CADENCE 21

Recommendation Meeting #2

111 21st Avenue Seattle, WA 98122

SDCI Number: 3025782

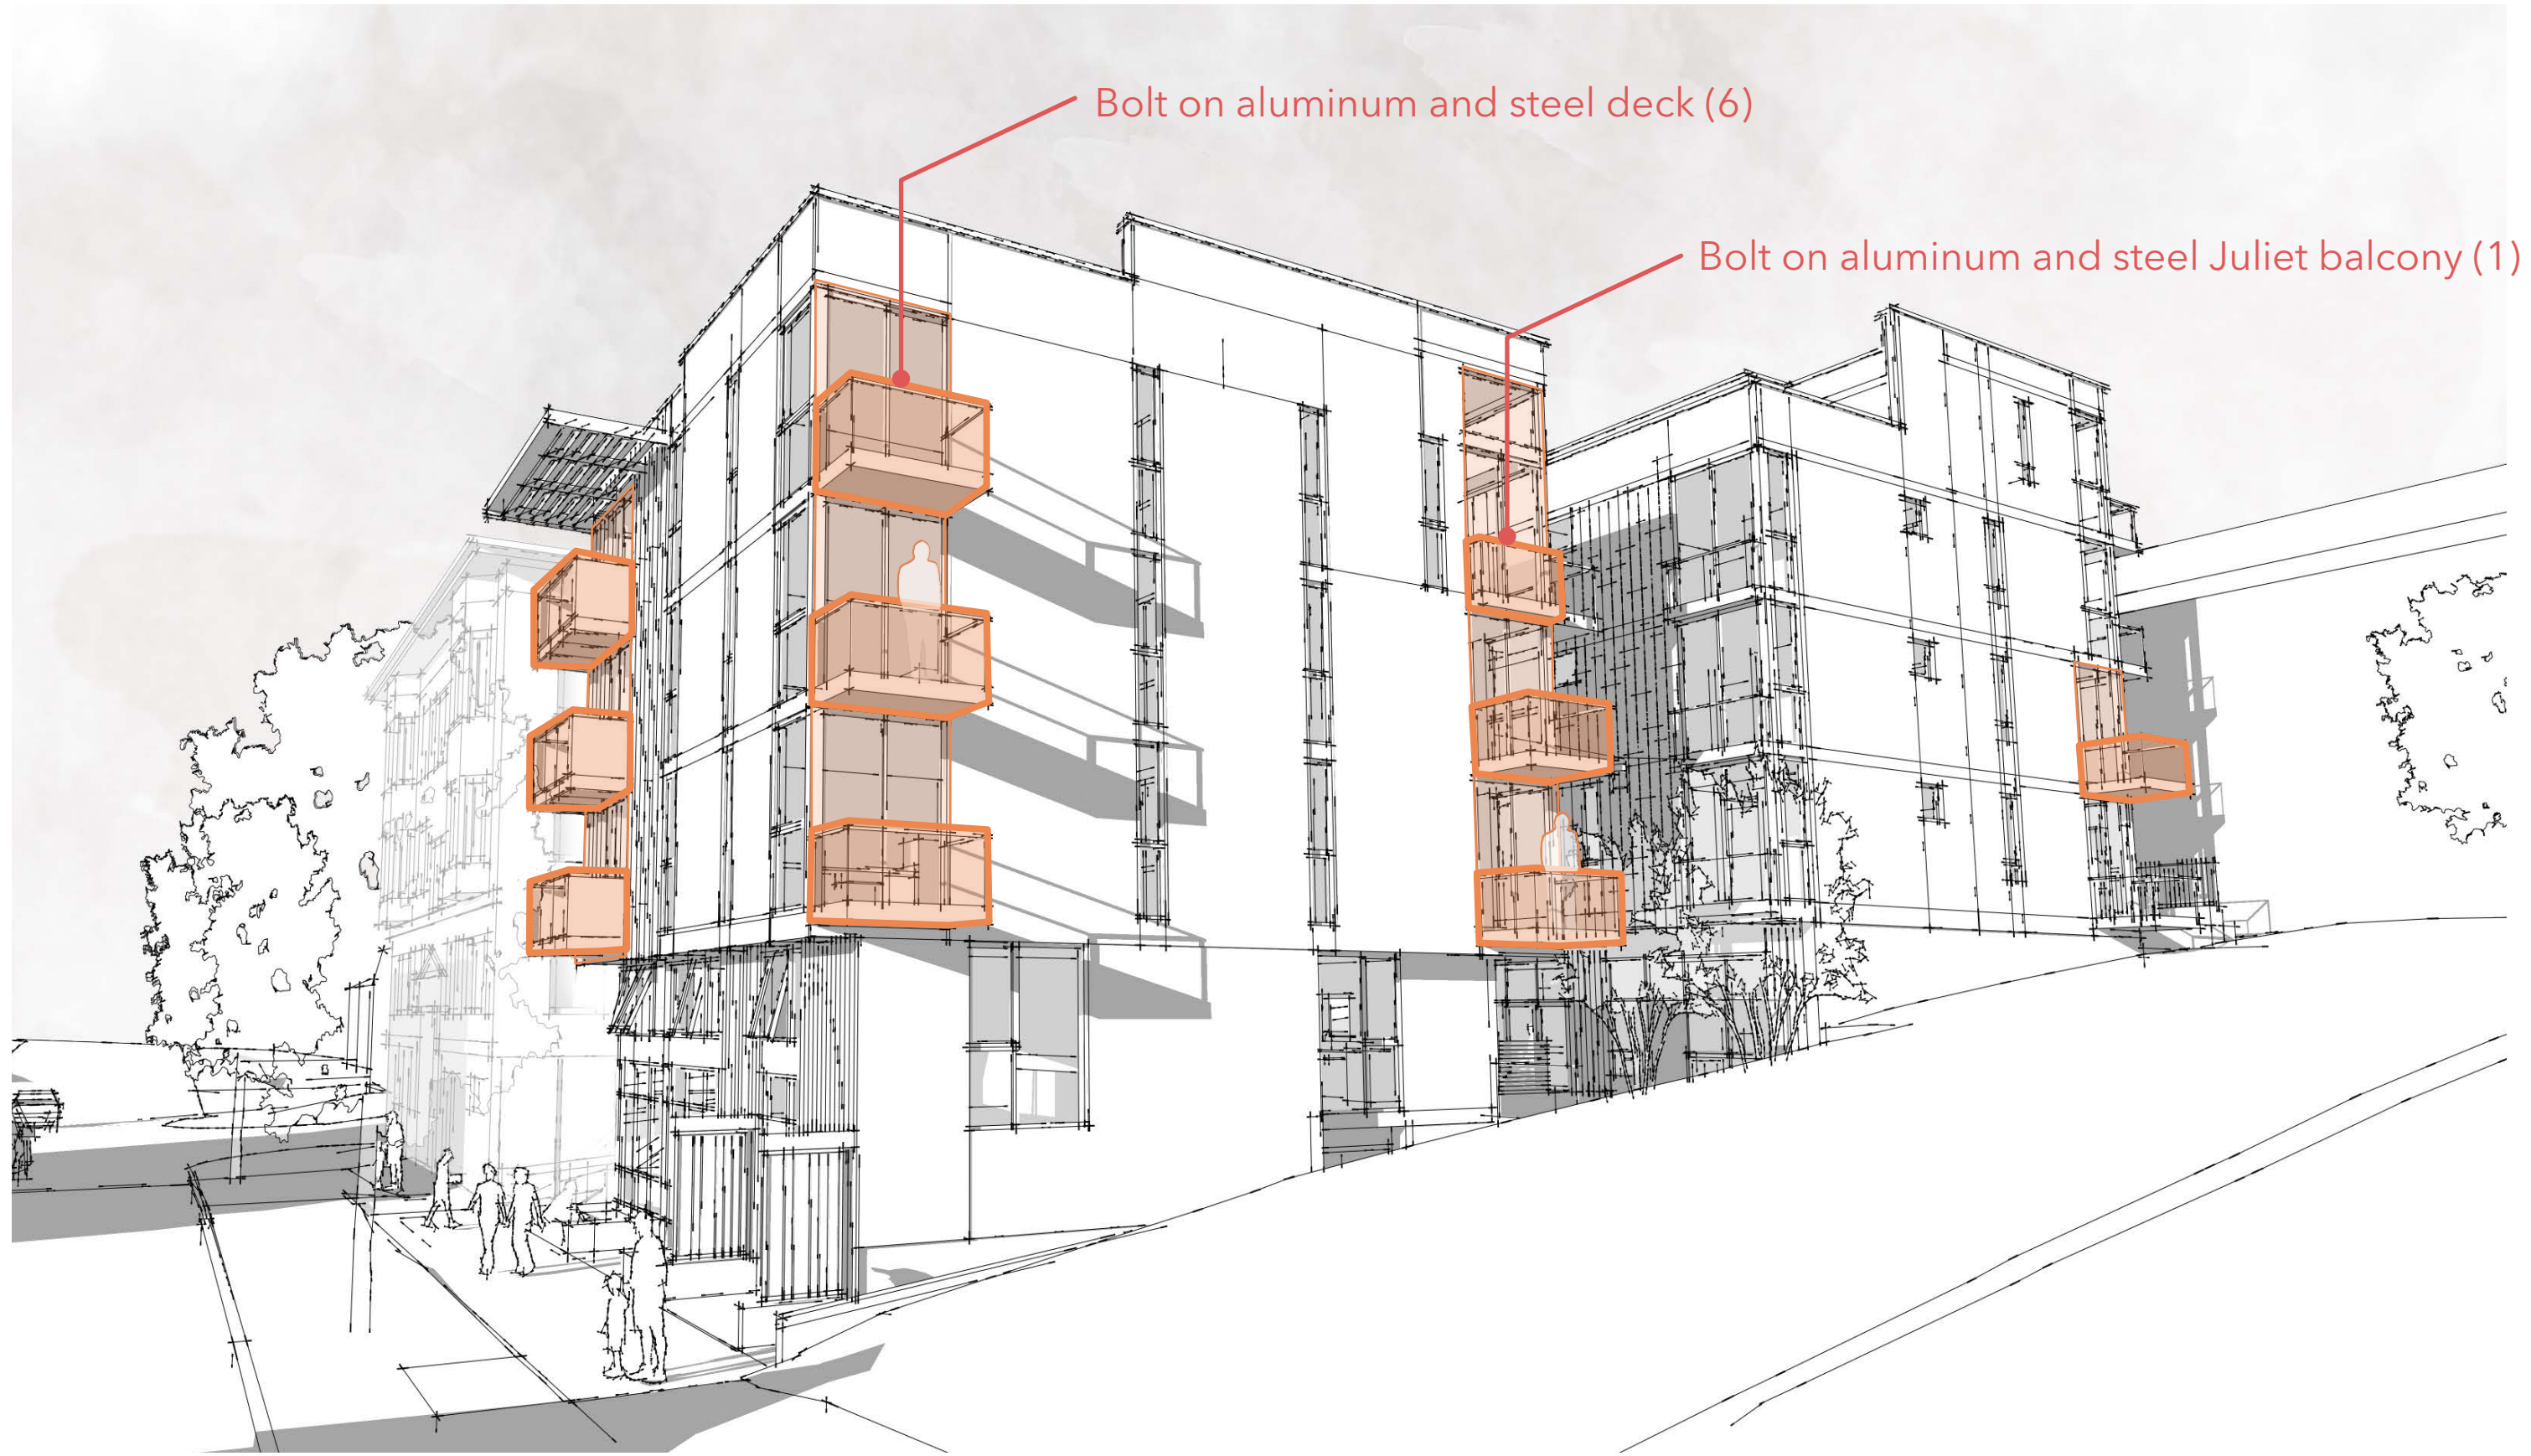
Departure 4a: Unenclosed decks within setbacks

- Unenclosed decks are not allowed in setbacks

- 3 decks with front setback, 6 decks within side yard setback. 1 Juliet balcony within side yard setback.

- 3 decks that are compositionally aligned over the lobby space create a bay-like vertical expression, similar to the projecting bays of the Clairemont building

Proposed overhang

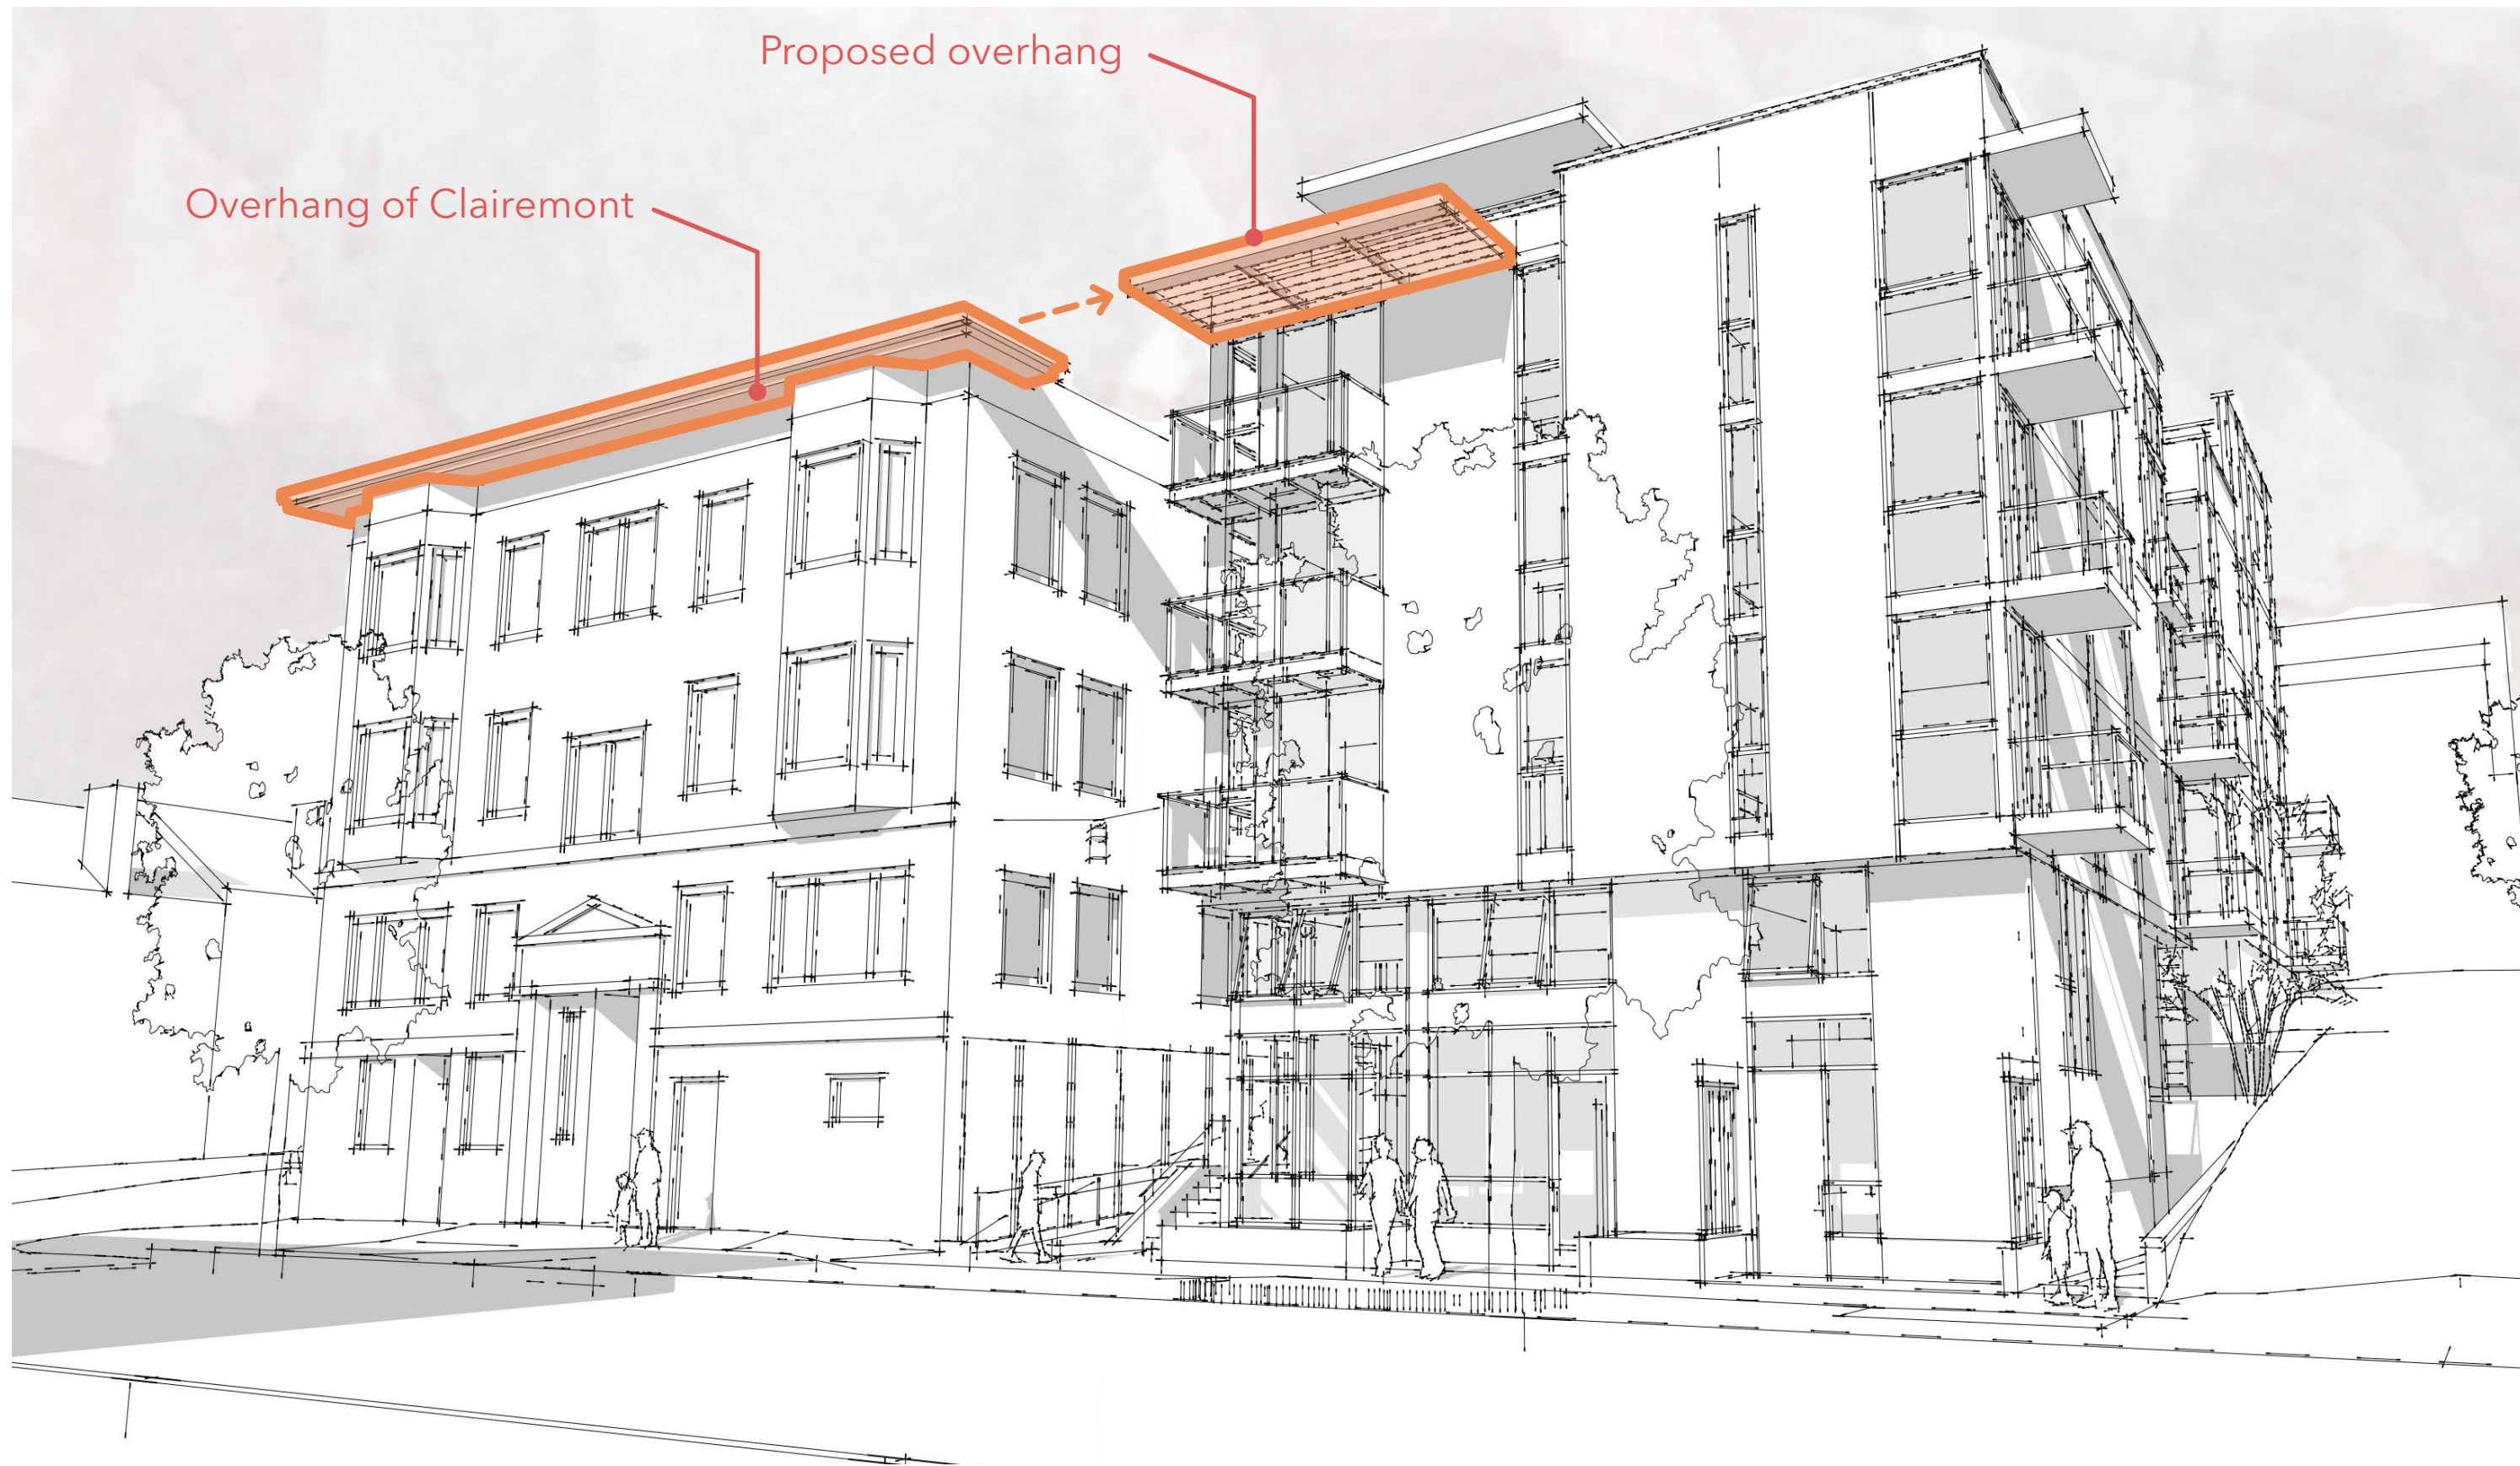
Departure 4b: Cornice element in front setback

- Cornices, eaves, gutters, roofs and other forms of weather protection may project into required setbacks and separations a maximum of 4' if they are no closer than 3' to any lot line

- Cornice extends into front setback

- The roof overhang serves several functions, but most notably it matches and continues the cornice line of the Claremont Apartments.

Setback Plan

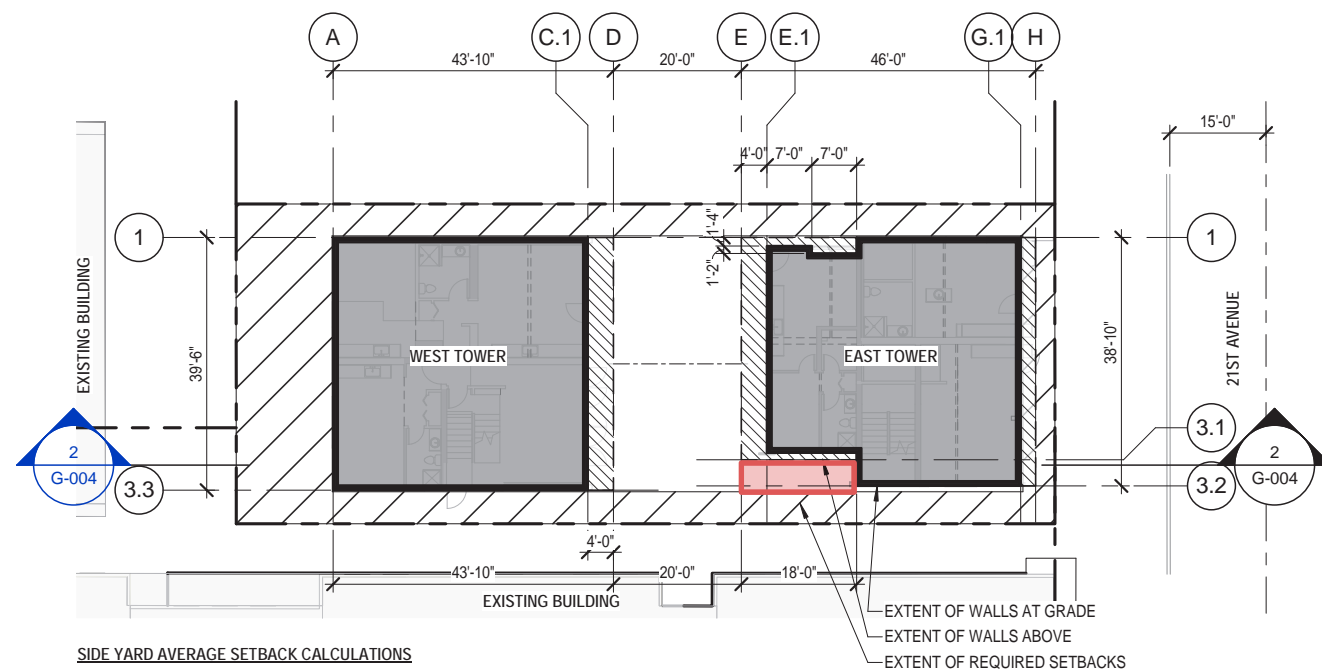
Departure 1: Setbacks

FRONT SETBACK FOR APARTMENTS: 5 FT MINIMUM

UPPER LEVEL SETBACK FOR LR ZONES: 16 FT MINIMUM ABOVE 44 FT

REDUCE FRONT SETBACK TO 3 FT MINIMUM WHILE PROVIDING ADDITIONAL SETBACK TO THE SOUTH YARD SETBACK

PARAPET AND ROOF ELEMENTS WITHIN THE 16' UPPER LEVEL SETBACK, WHILE KEEPING SIGNIFICANT PORTIONS OF BOTH BUILDINGS BELOW THE OVERALL BUILDING HEIGHT REQUIREMENT.

THE CURRENT SIDEWALK & RIGHT OF WAY ARE VERY DEEP (18 FT). THE PROPERTY LINE IS 7 FT FROM THE RIGHT OF WAY & THERE IS AN ADDITIONAL 11 FT OF SIDEWALK/PLANTING TO THE CURB. ANY ADDITIONAL SETBACK BEYOND THE CURRENT 18 FT FROM THE CURB LINE WOULD BE DETRIMENTAL TO AN URBAN CONTEXT. ADDITIONALLY, A NARROWER 3 FT SETBACK IS MORE IN LINE WITH THE NEIGHBORING BUILDING SOUTH OF OUR SITE. THAT BUILDING HAS NO SETBACK & PROVIDES A STRONG ANCHOR FOR ARCHITECTURAL CONTEXT. FURTHERMORE, ADDITIONAL SETBACK AREA IS BEING PROVIDED TO THE SOUTH SIDE YARD SET BACK. THIS RELINQUISHED AREA IS GREATER THAN THE AREA OF SETBACK LOST TO THE FRONT SETBACK.

North Facade Calculation

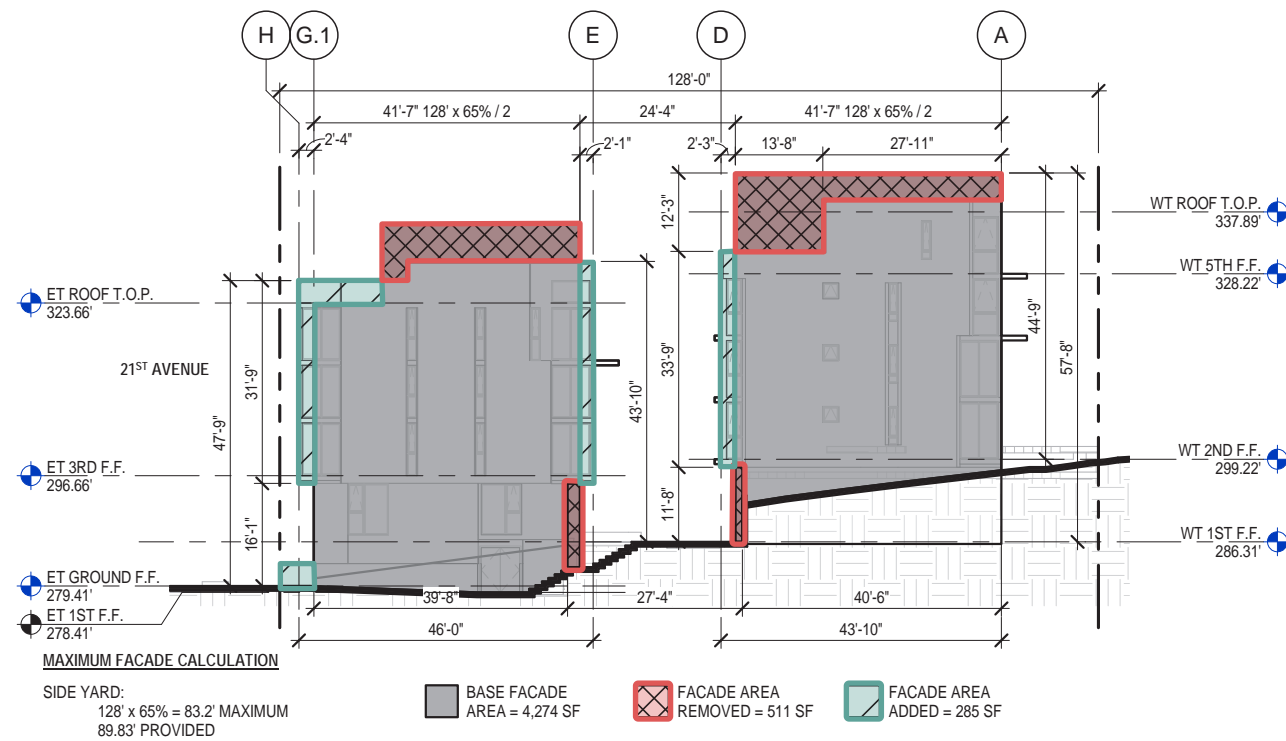
Departure 2: Facade Length

SIDE LOT LINE = 128 FT x 65% = 83.2 FT ALLOWED

PROPOSED FAÇADE LENGTH = 89.83 FT > 83.2 FT ALLOWED

IN ORDER TO CREATE A MORE INTERACTIVE & SUCCESSFUL OPEN SPACE AT THE CENTER OF OUR SITE WE WOULD LIKE TO DEPART FROM THE MAXIMUM FAÇADE WIDTH LIMIT OF 83.2 FT. OUR RATIONALE FOR EXCEEDING THE MAXIMUM FAÇADE WIDTH IS TO TRADE POTENTIALLY DEVELOPABLE AREA AT THE GROUND LEVEL & ROOF FOR ADDITIONAL BUILDING WIDTH. THE MAXIMUM DEVELOPABLE FAÇADE AREA IS 3,601 SF & OUR PROPOSAL HAS A FAÇADE AREA OF 3,474 SF. NOT ONLY DOES OUR BUILDING FORM ENHANCE & REINFORCE A MORE SUCCESSFUL OPEN SPACE BUT ITS FAÇADE AREA IS LESS THAN THE MAXIMUM AREA ALLOWED.
